March 30, 2023

**SUBJECT: NEW VEHICLE DEMONSTRATION / DELIVERY HOLD
Compliance Recall 23C02
Certain 2023 Model Year Transit
Wiring Harness Missing Jumper Loop**

SUBJECT: FSA 23C02 HVAC Function Validation

FIGURE 2

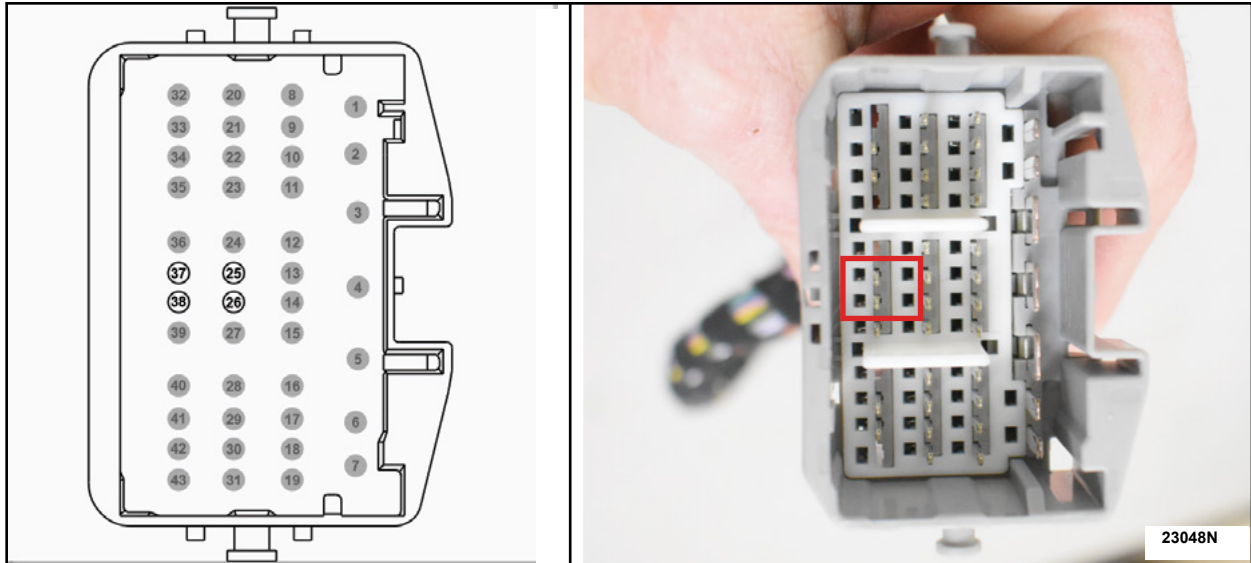
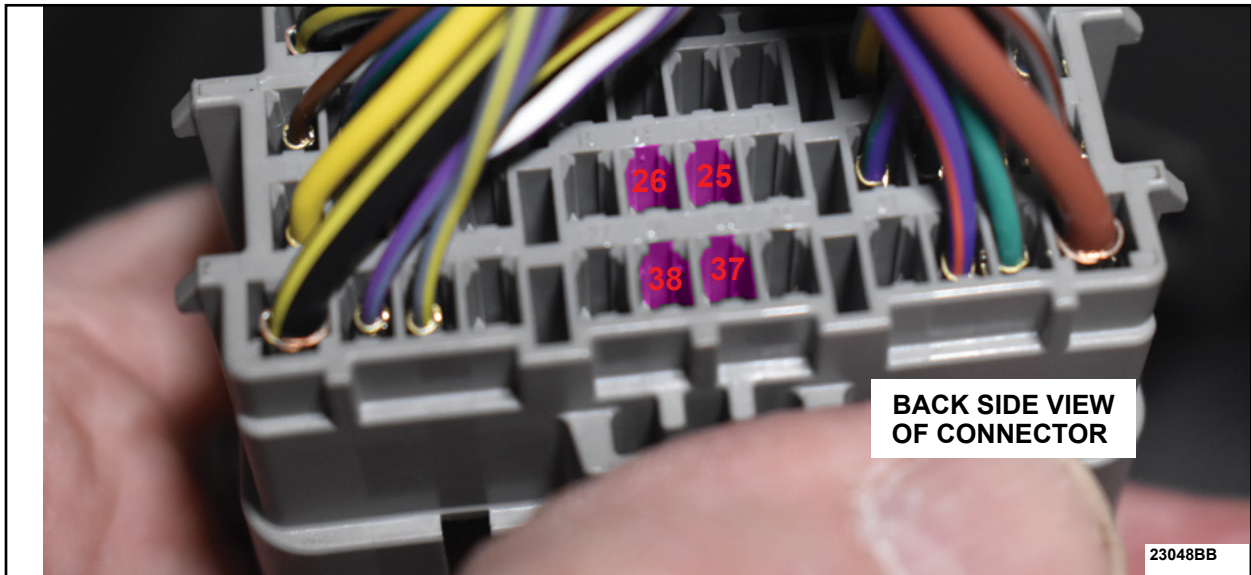
3. Locate pin terminal numbers 25, 26, 37 and 38 from within the auxiliary climate control upfitter harness connector as shown in Figures 2 and 3.

FIGURE 4

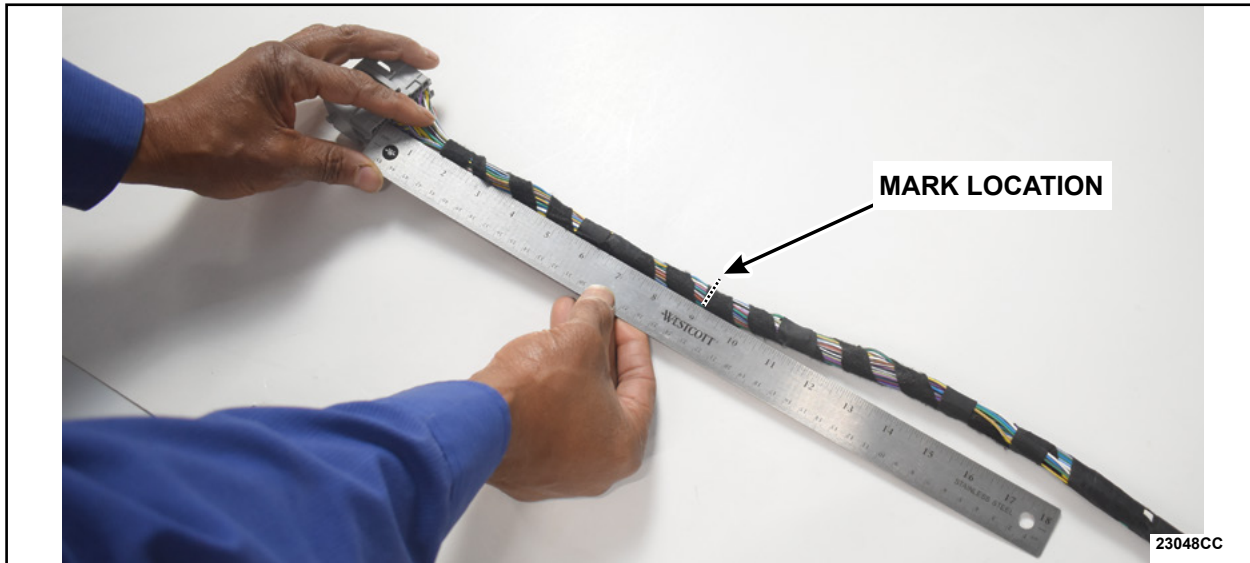
4. Measure 9 in (229 mm) from the connector and mark the location of how far to open the harness in the next Step. See Figure 4.

FIGURE 7

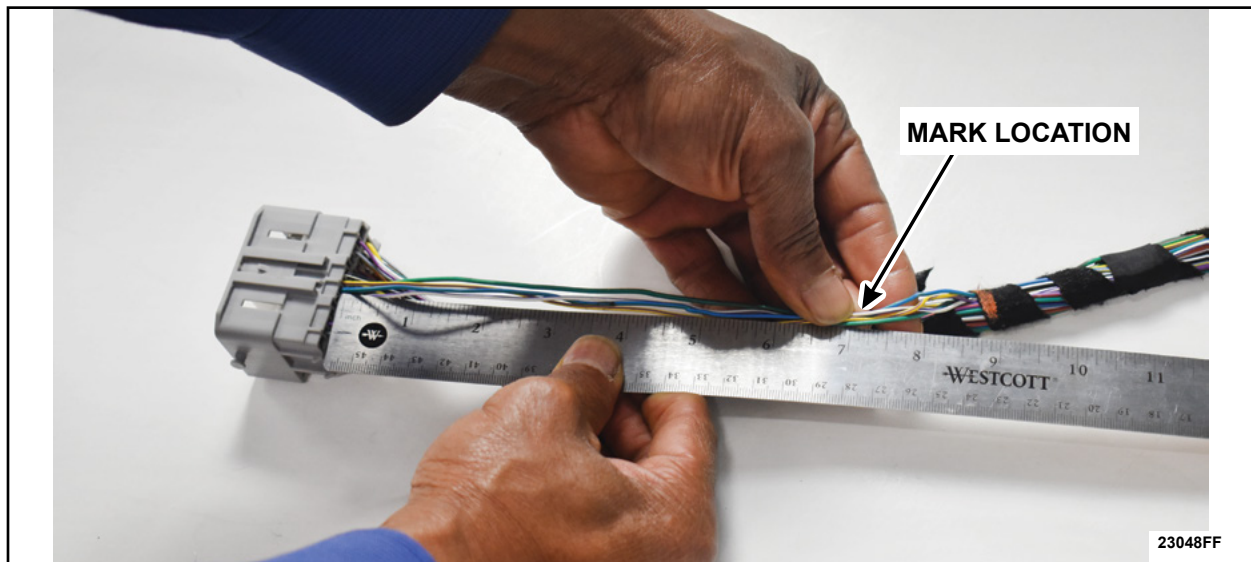
7. Starting at the connector end, measure 7 in (178 mm) down all four (4) wires and mark the location. See Figure 7.

FIGURE 8

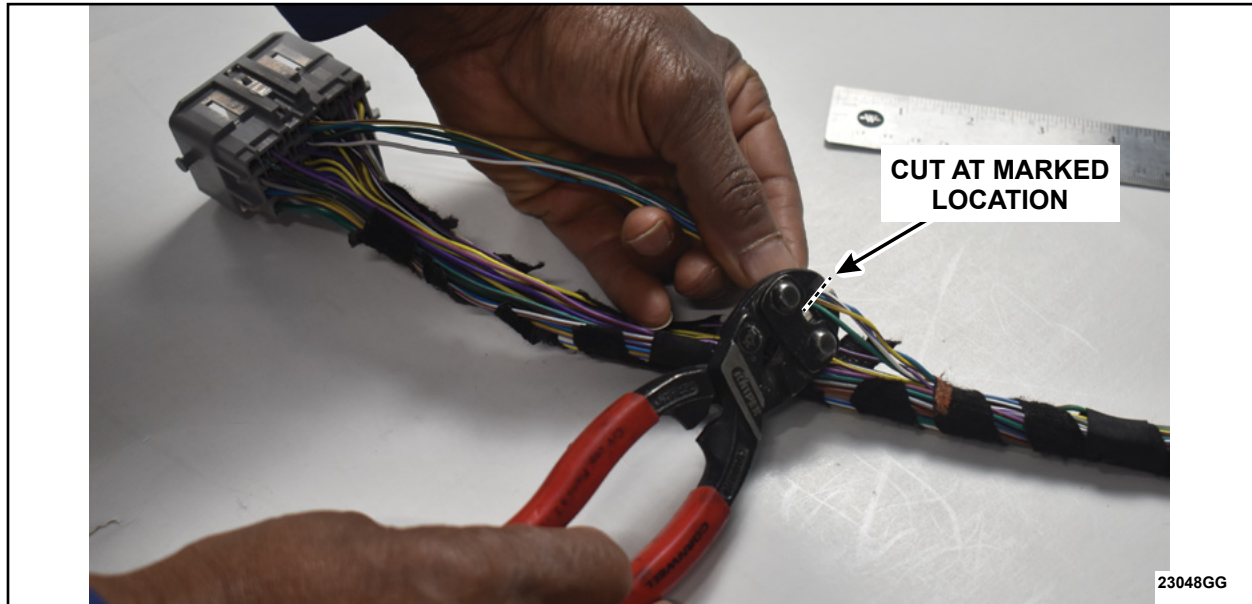
8. Cut all four (4) wires at their marked location. See Figure 8.

FIGURE 9

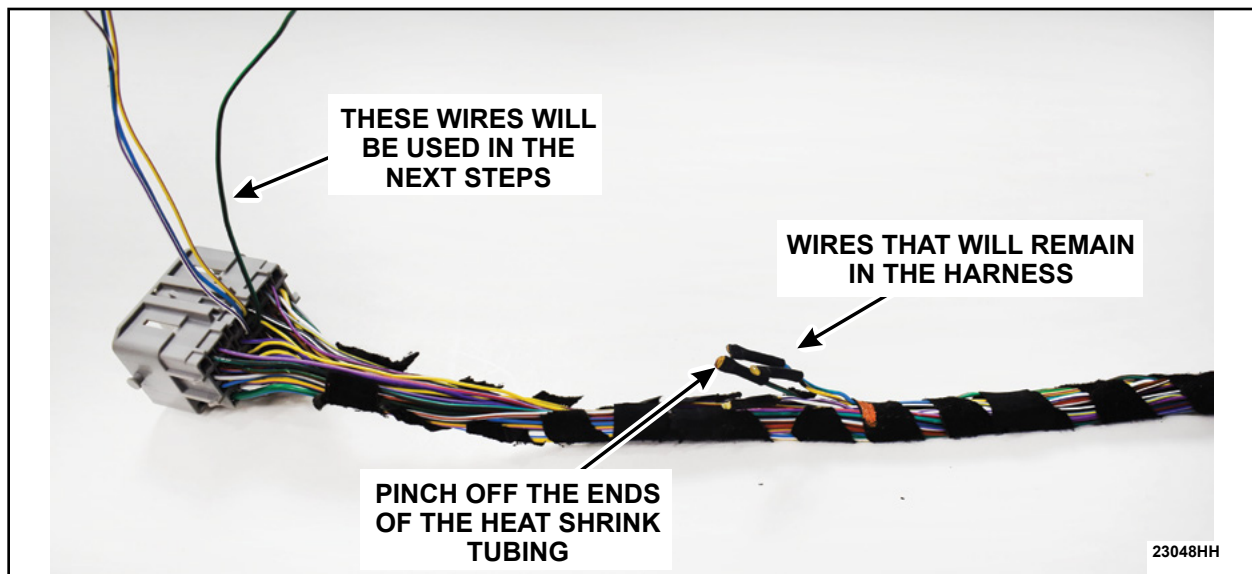
9. Apply a dual wall heat shrink tube over the ends of all four (4) wires, that will remain in the harness, and pinch off the ends. See Figure 9.

FIGURE 11

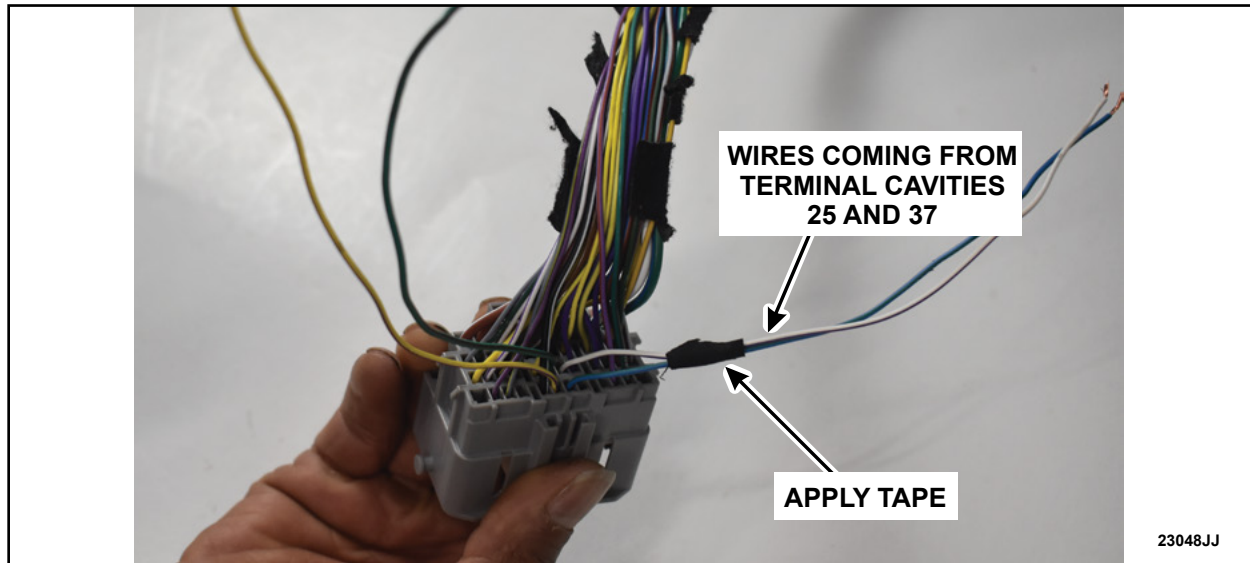
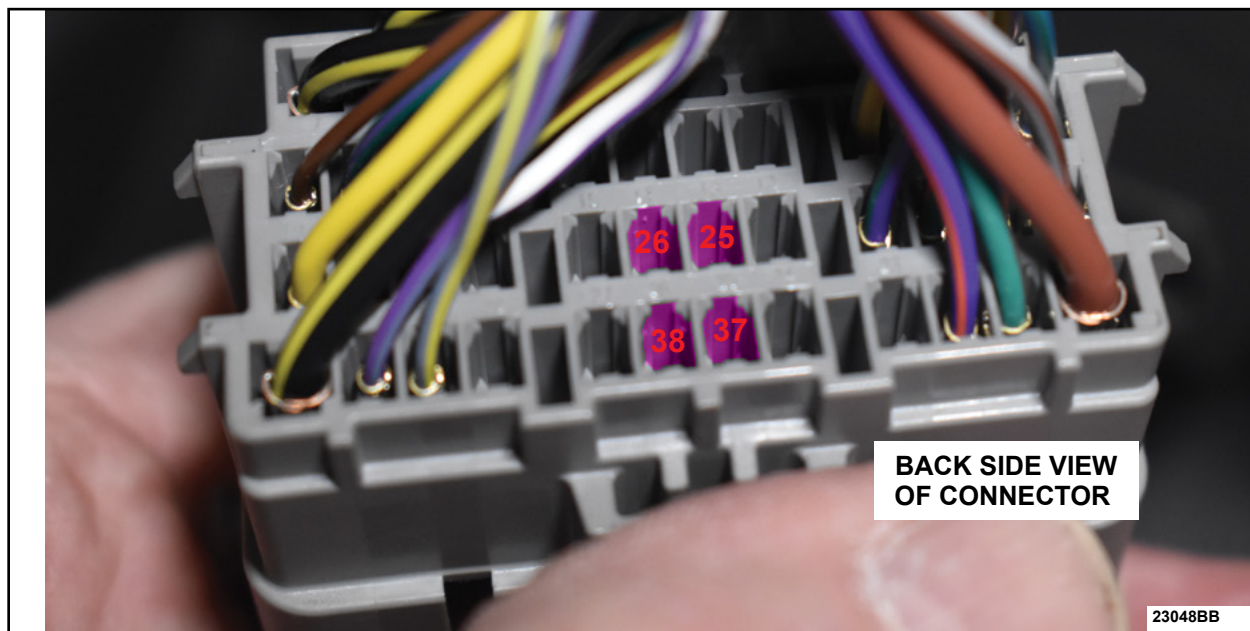
11. Strip back .5 in (13 mm) of wire insulation from the ends of the 4 wires that are left going back into the harness connector.
12. Measure 2 in (50 mm) from the connector up the wires located in cavities 25 and 37 and apply electrical tape. See Figure 11. See Figure 12 for terminal cavity locations.

NOTE: Make sure the wires between the connector body and the tape installed are not twisted and no tension is being applied on the connector terminals.

FIGURE 13

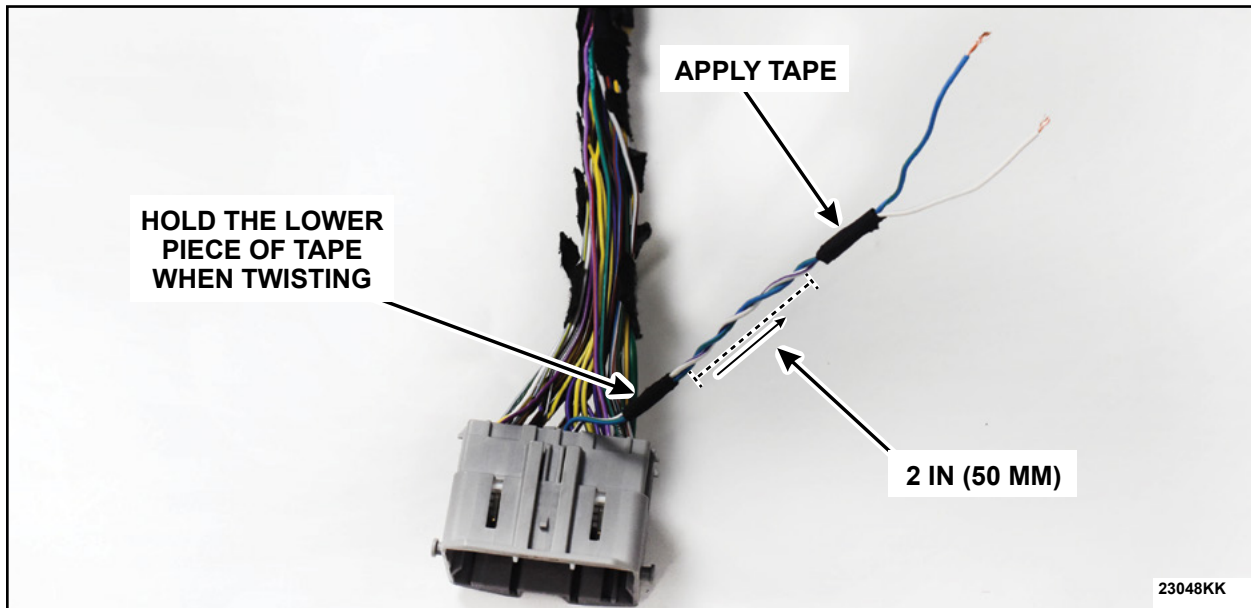
13. Measure 2 in (50 mm) up from the first piece of electrical tape applied and apply another piece of electrical tape. Holding the lower piece of electrical tape twist the pair of wires four (4) times. See Figure 13.

NOTE: Make sure to hold the piece of electrical tape closest to the connector when twisting the wires and that there are at least four (4) twists, within the 2 in (50 mm) measured, between the two (2) pieces of electrical tape that were applied.

FIGURE 15

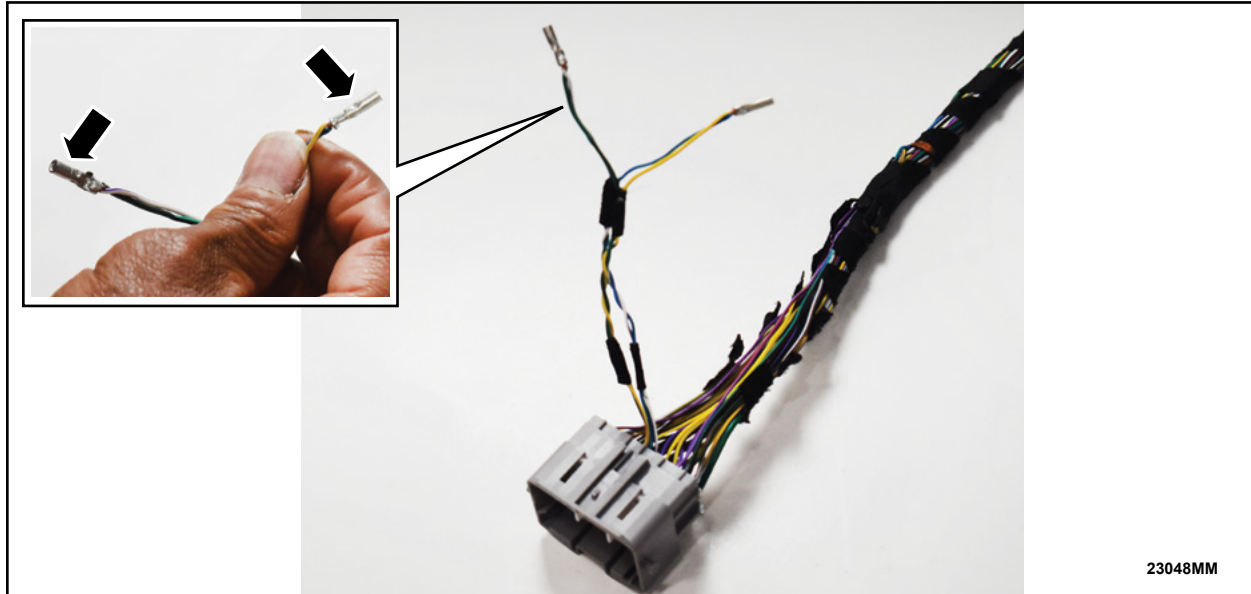
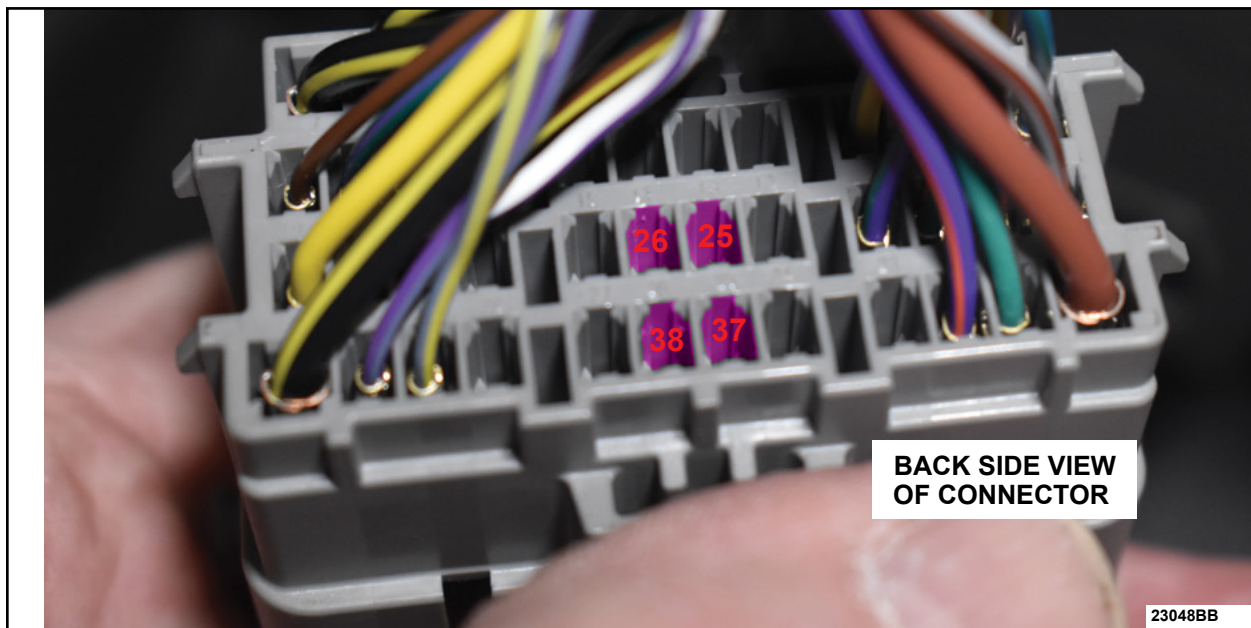
15. Twist together wires from cavities 25 and 26 and install a butt connector over the connection and crimp the wires. See Figures 15 and 16.
16. Twist together wires from cavities 37 and 38 and install a butt connector over the connection and crimp the wires. See Figures 15 and 16.

FIGURE 17

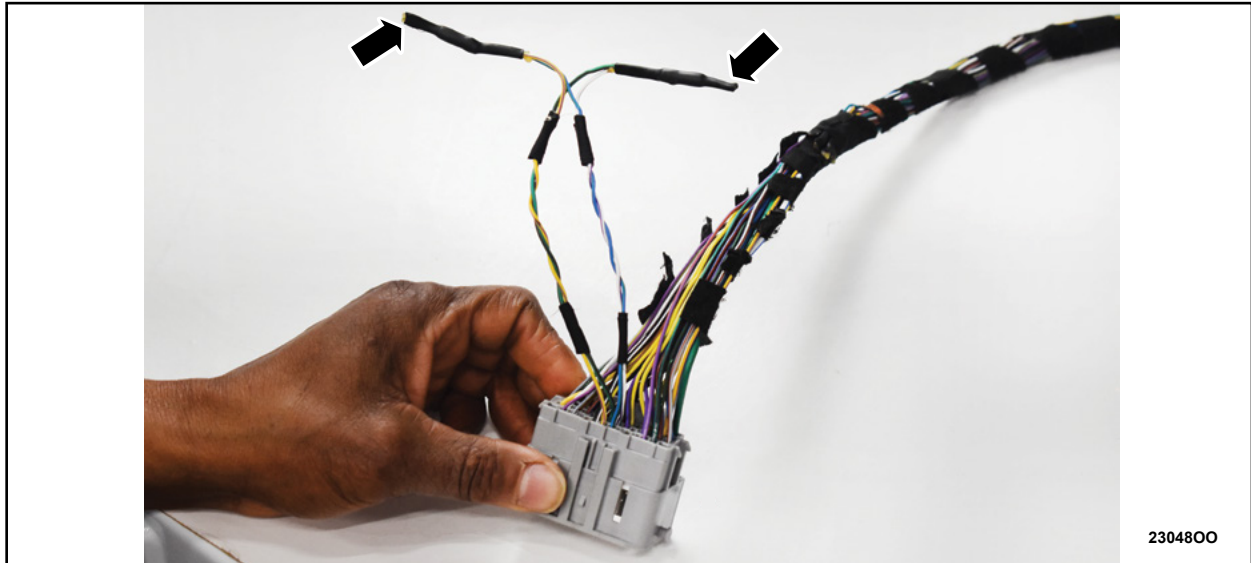
17. Install a dual wall heat shrink tube over both butt connectors and heat tube and pinch off the ends as shown in Figure 17.

FIGURE 18

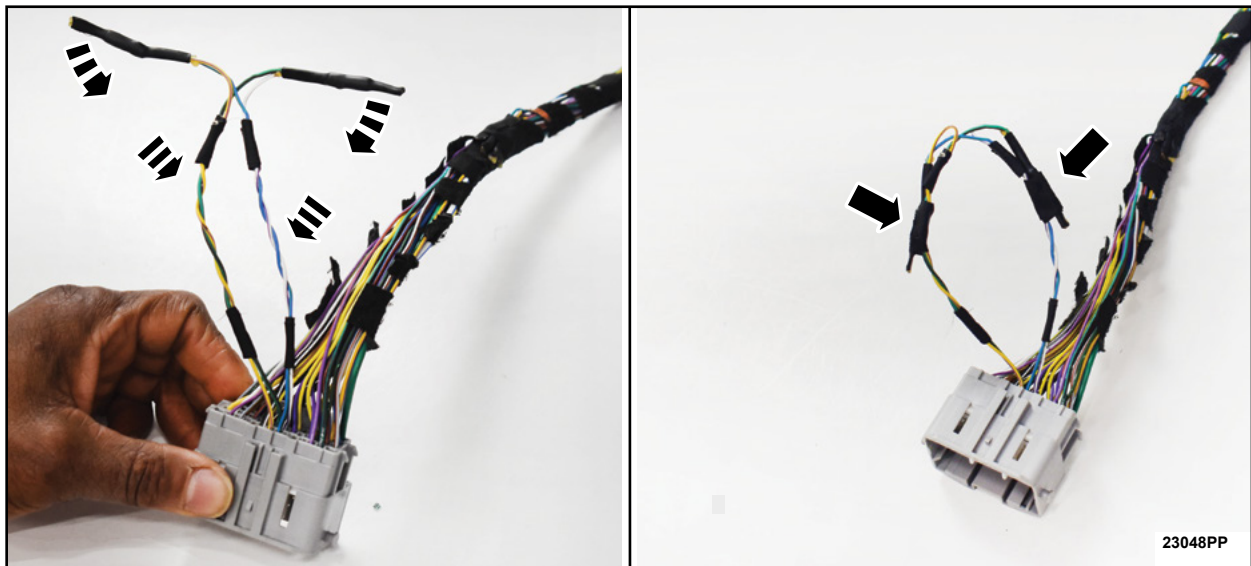
18. Using electrical tape, secure both sets of crimped wires to the circuits just created, as shown in Figure 18.

FIGURE 19

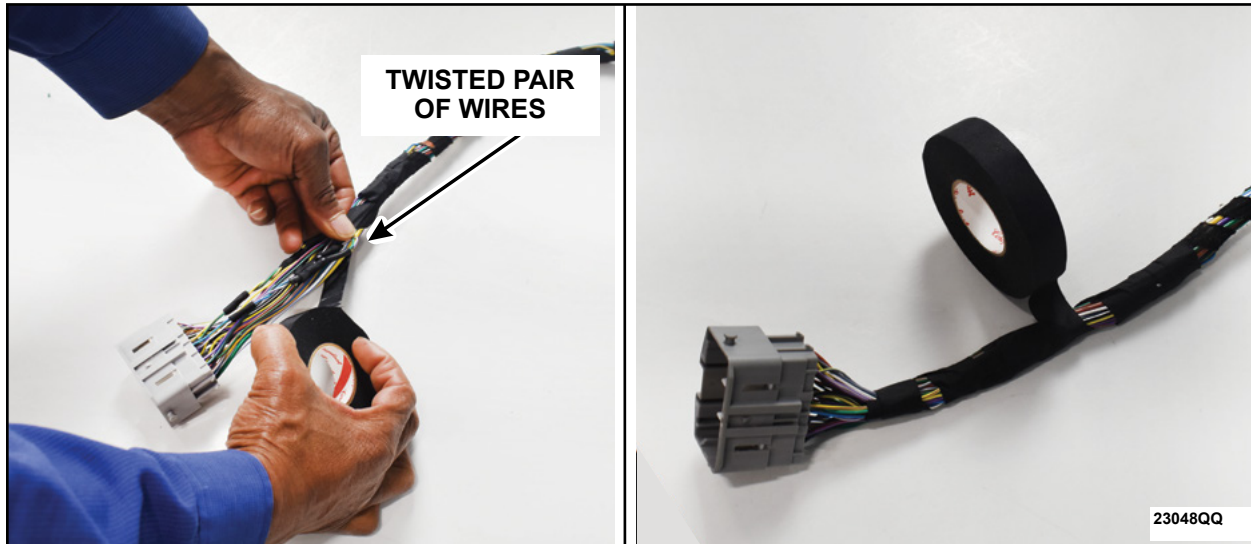
19. Remove any excess electrical tape from the harness that was left behind when opening up the harness.
20. Lay the twisted pair of wires along the wiring harness and tape the harness back up, including the twisted pair of wires. See Figure 19.
